Future Land Use Map  
 SP-23001, Beason Property  
 Site Plan Approval for The Landing Renovation & Addition

Request: Addition & Remodel of current  
facility.

### PLANNING COMMISSION STAFF ANALYSIS

Case Number: SP-23001

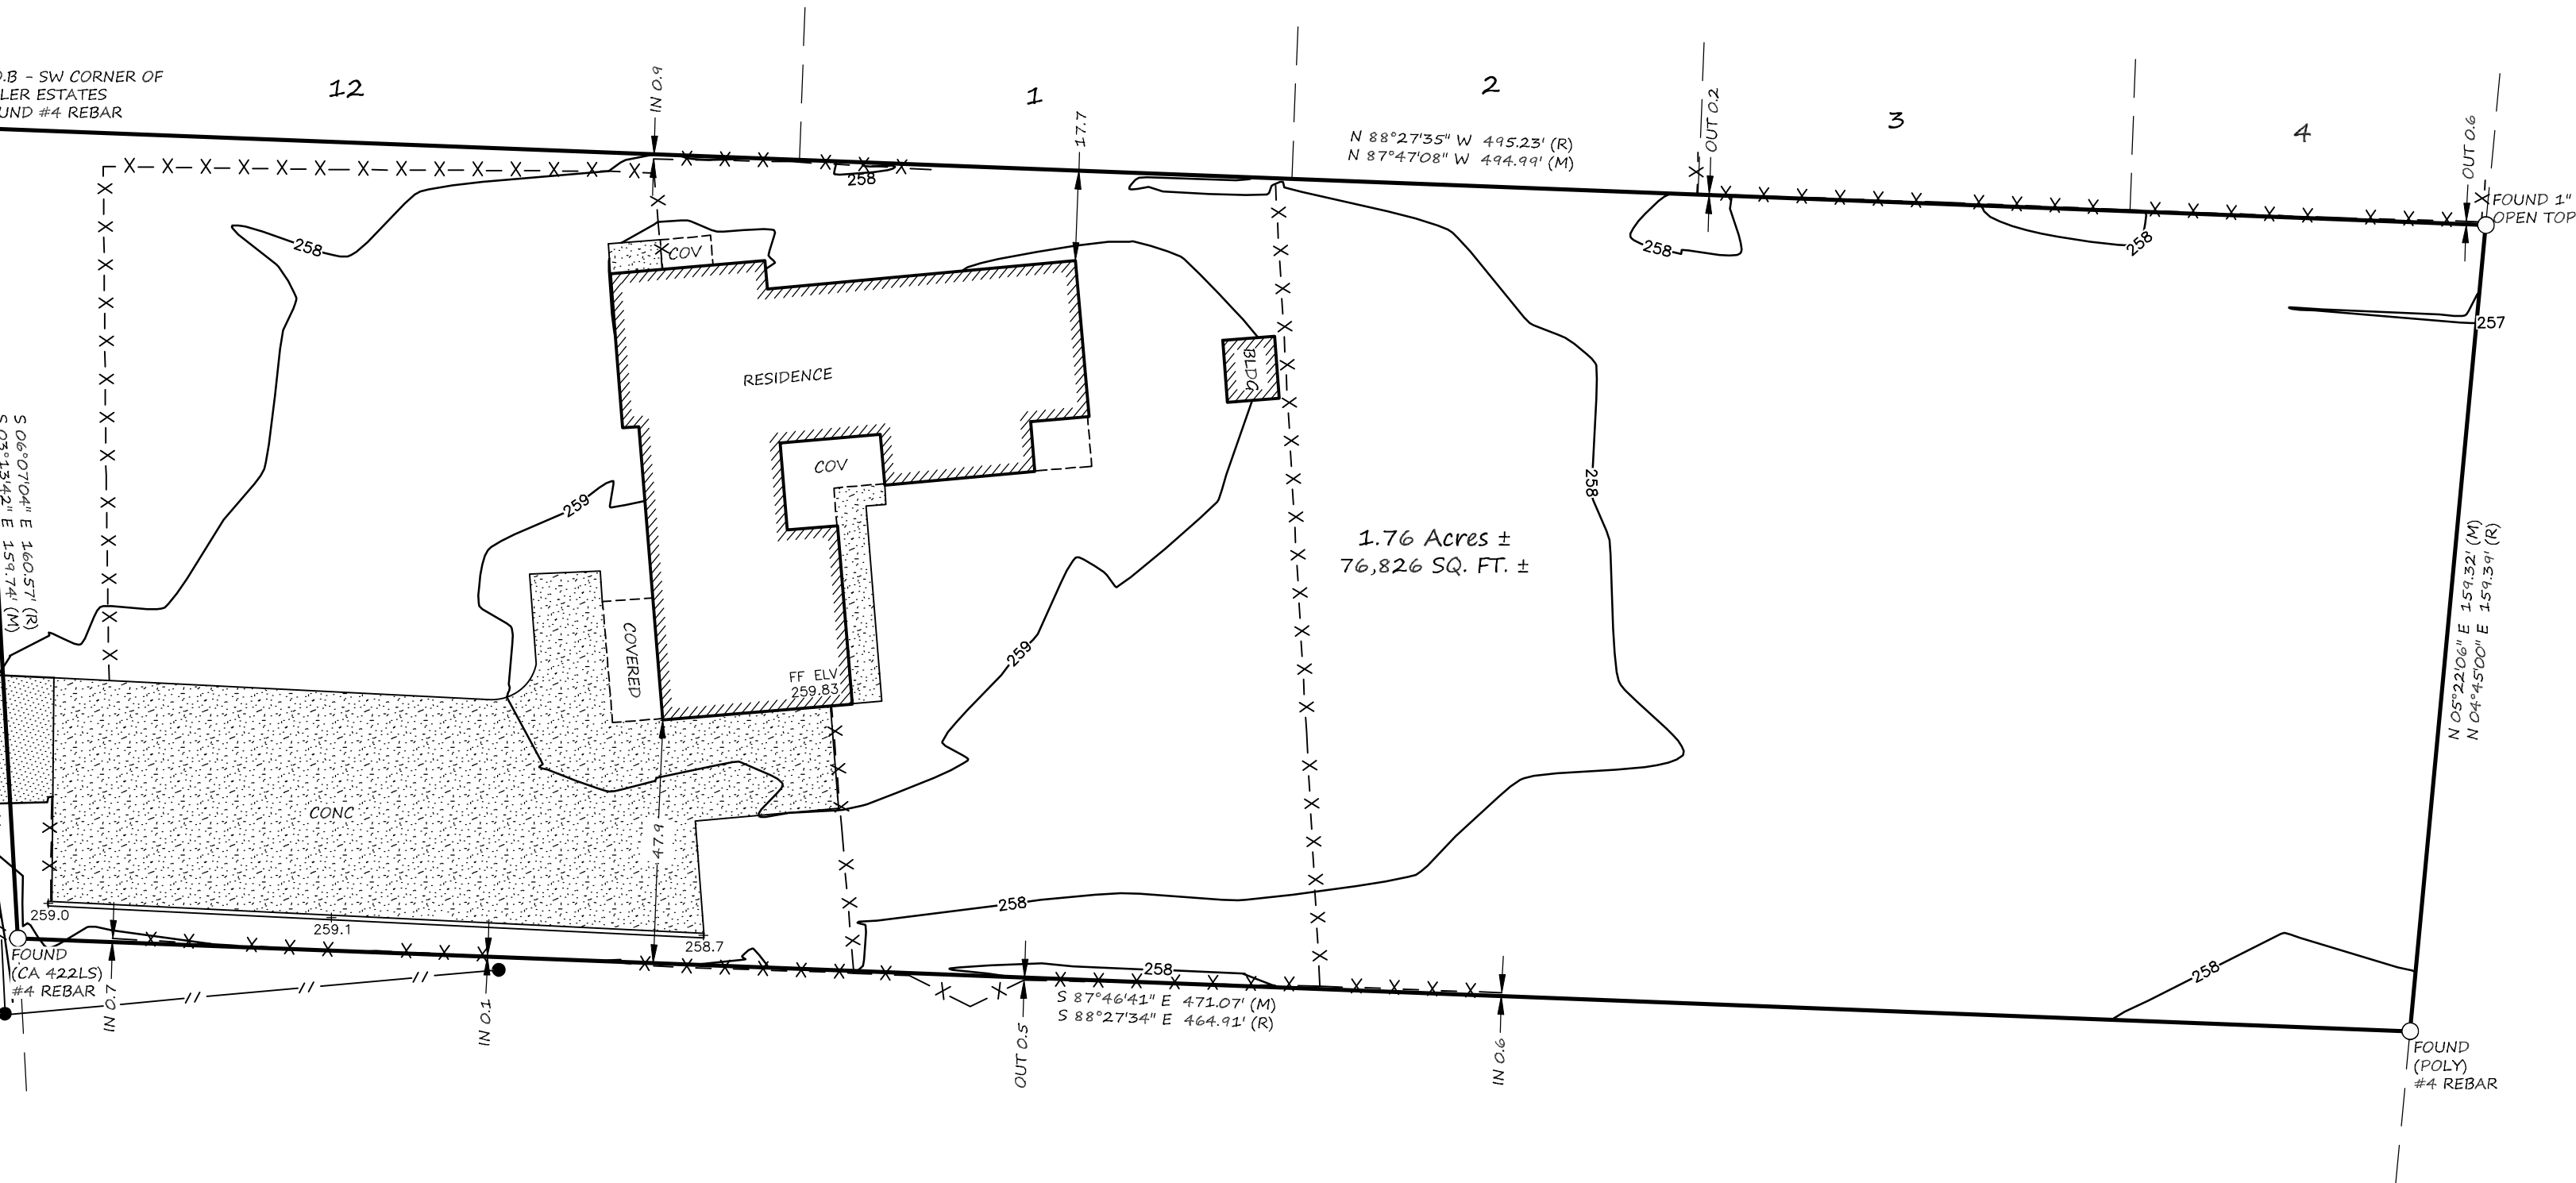
The proposed site plan shows a building footprint of 31'x148'4" with a covered porch area of 24'6"x10' for a total of approximately 4,342ft<sup>2</sup>. for the new wing. The existing structure is approximately 6,339ft<sup>2</sup> under roof and contains 13 bedrooms; office, laundry, kitchen, dining and meeting space; plus a covered porch and patio. The majority of renovations proposed for this structure primarily affect interior finishes, HVAC work, window replacement or infill - all outside the scope of the Planning Commission's review. The construction of the new wing, parking area and future pavilion are items within the Commission's review authority as the development increases and/or alters the footprint, lot coverage, intensity and structure locations.

The new wing will add approximately 4,047ft<sup>2</sup> of conditioned space and 295ft<sup>2</sup> of unconditioned area with the covered deck. It contains approximately 1,200ft<sup>2</sup> of meeting space, a laundry area and five bedrooms. The new wing has a total occupancy of 17 - one Manager's room & four shared-occupancy bedrooms each containing four beds, two closets and one bathroom. The new wing will bring the facility's total occupancy to 30 residents and staff.

Submitted elevations show the addition's finishes will match the existing structure. The new roof will match the type, color and slope of the existing roof with an approximate height of 16 feet. Space has also been dedicated for a 30'x40' pavilion in the rear yard on the NE side of the property for future development. Apartments were previously noted for future development, but no additional structures are proposed at this time. The Fire Inspector did note that if additional development is proposed in the future to the rear of the facility, a fire apparatus access road will be difficult, if not impossible to achieve between the south side of the new wing and the property line. This does not affect the current application and the applicant is aware of and understands the potential barrier to the future development of apartments.

**Open Space & Landscape Provisions // General:** For this property, approximately 11,523ft<sup>2</sup>// .26+ acres, will be required to be landscaped or remain open space. A landscape plan was not submitted, but based on the submitted plans and GIS information, the percentage of open grassed and natural area is estimated at approximately 67.42%. That amount will change slightly based on required landscaping of off-street parking areas and Greenbelt Zone. The balance of the site will remain as natural green space, easily exceeding the 15% requirement.

**Off-Street Parking:** Plans show a total of 20 10'x20' parking spaces in the front. Boarding and rooming houses require one space for each guest bedroom. There are 13 existing bedrooms, and the new wing will accommodate 5 additional bedrooms for a total of 18 required spaces.

The access widths are noted on the plan at the minimum required width of 24-feet for two-way access driveways within parking areas.

- 1.) The applicant submit a landscaping plan satisfying the provisions for the disposition of open space, including tree protection, Greenbelt Zone standards, off-street parking landscaping provisions, and buffering requirements prior to the issuance of a building permit.
- 2.) Prior to the issuance of a Building Permit for the construction of the proposed pavilion, the applicant shall submit a Land Use Application and Site Plan for review of setback and other minimum requirements.
